ADDENDUM NO. 1
TO THE
DRAWINGS AND PROJECT MANUAL
FOR
NORTH SHORE MULTI-USE INDOOR FACILITY
GALENA PARK INDEPENDENT SCHOOL DISTRICT
HOUSTON, TEXAS

STRUCTURAL ADDENDUM NO. 1 ITEMS

SHEET TITLE
FOUNDATION PLAN - UNIT B

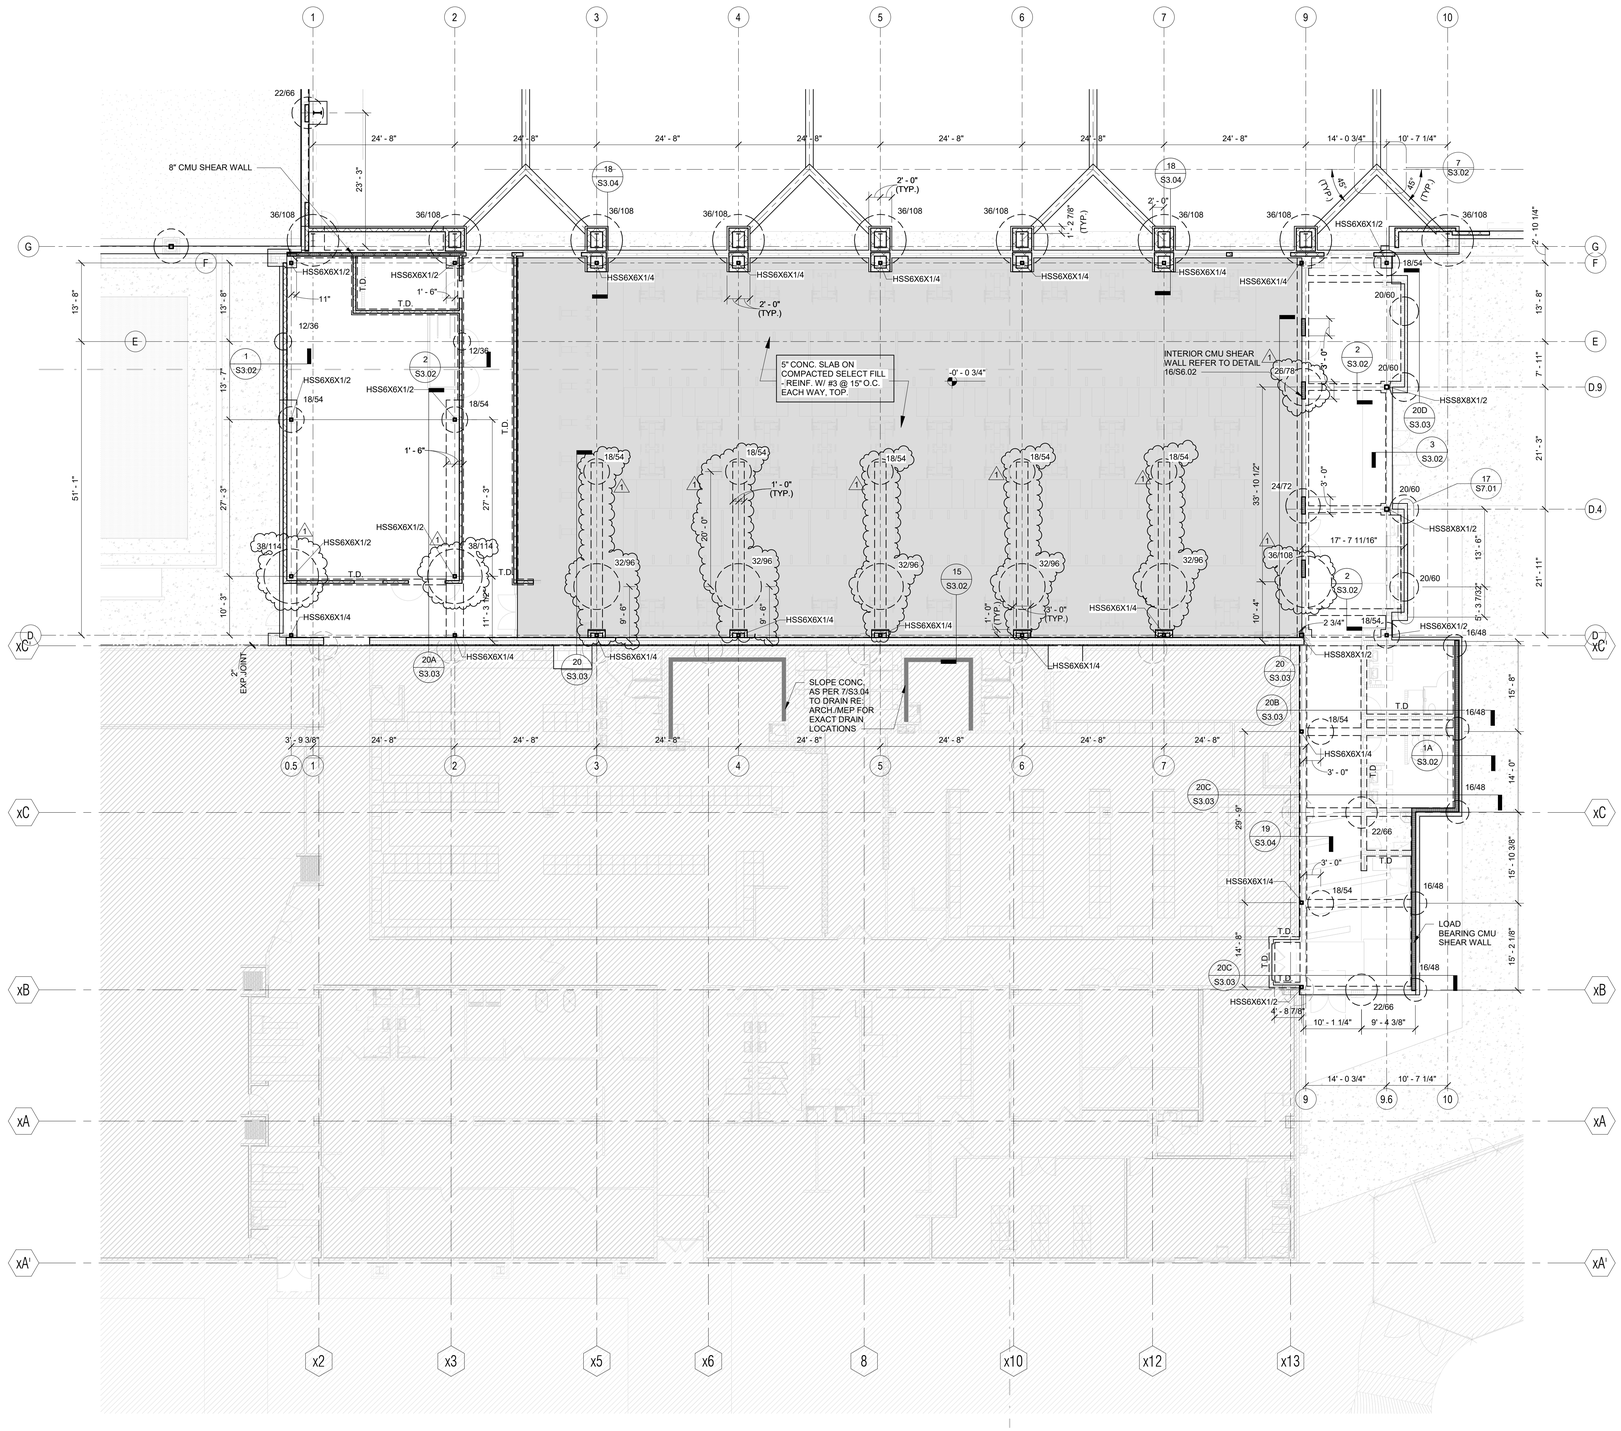
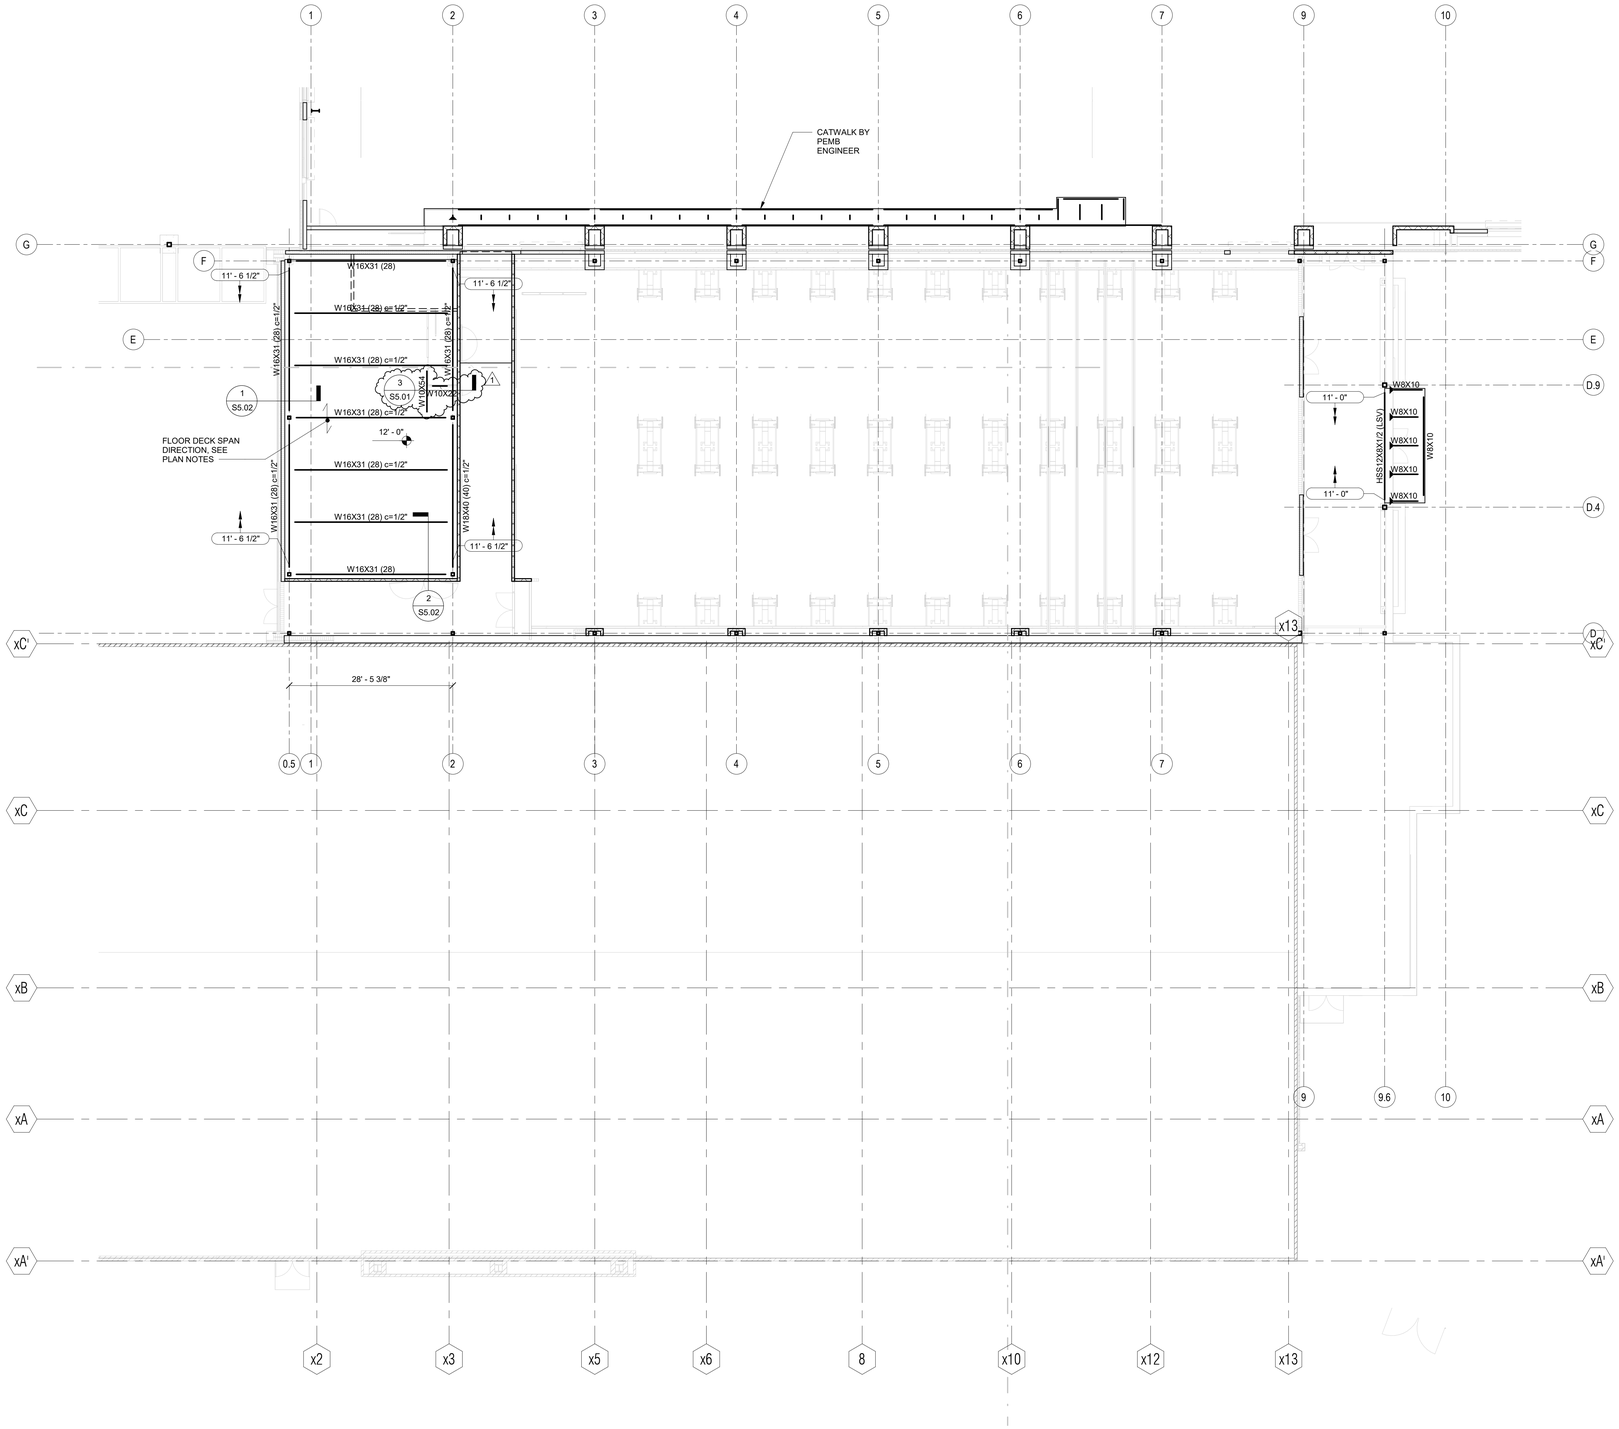
A. Pier sizes on gridlines 0.5, 2, 3, 4, 5, 6, 7, 9 & 9/D.9 updated

B. Cantilever grade beam sizes updated on gridlines 3, 4, 5, 6, 7 & 9
